FIVE POINTS PHASE 2  
INFRASTRUCTURE IMPROVEMENTS  
FIVE POINTS, KNOXVILLE, TN

SITE DEMOLITION PLAN ADDENDUM

SITE LAYOUT PLAN ADDENDUM

SITE UTILITY PLAN ADDENDUM

DRAWN BY:	GMW	CHECKED BY:	GHP	APPROVED BY:	GMW	FIGURE NO.:	C511A
DATE:	JULY 6, 2016	DWG SCALE:	AS SHOWN	PROJECT NO.:	140-828

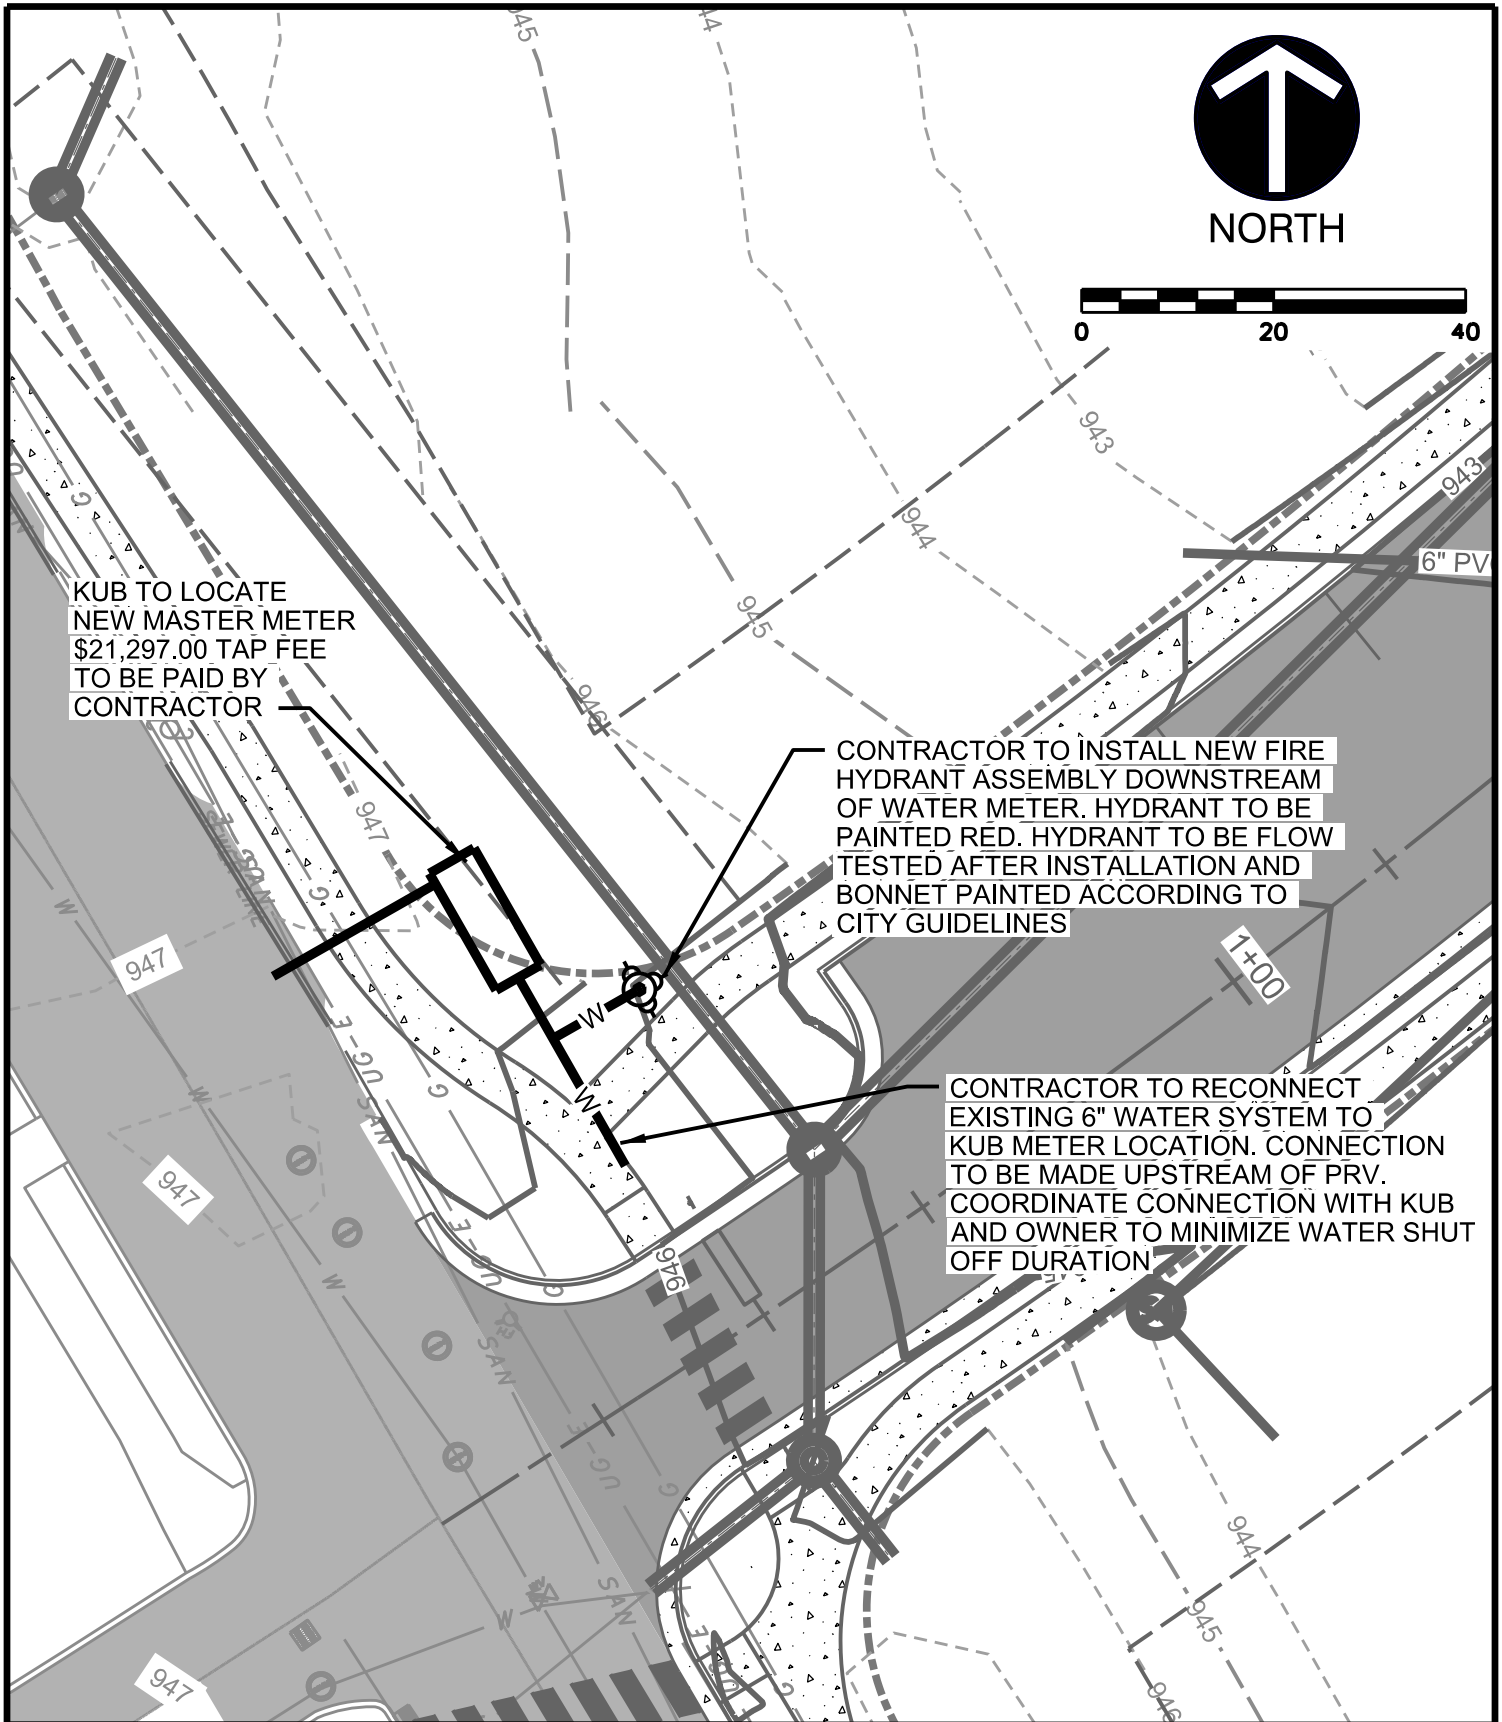
KUB TO LOCATE  
NEW MASTER METER  
\$21,297.00 TAP FEE  
TO BE PAID BY  
CONTRACTOR

CONTRACTOR TO INSTALL NEW FIRE  
HYDRANT ASSEMBLY DOWNSTREAM  
OF WATER METER. HYDRANT TO BE  
PAINTED RED. HYDRANT TO BE FLOW  
TESTED AFTER INSTALLATION AND  
BONNET PAINTED ACCORDING TO  
CITY GUIDELINES

CONTRACTOR TO RECONNECT  
EXISTING 6" WATER SYSTEM TO  
KUB METER LOCATION. CONNECTION  
TO BE MADE UPSTREAM OF PRV.  
COORDINATE CONNECTION WITH KUB  
AND OWNER TO MINIMIZE WATER SHUT  
OFF DURATION
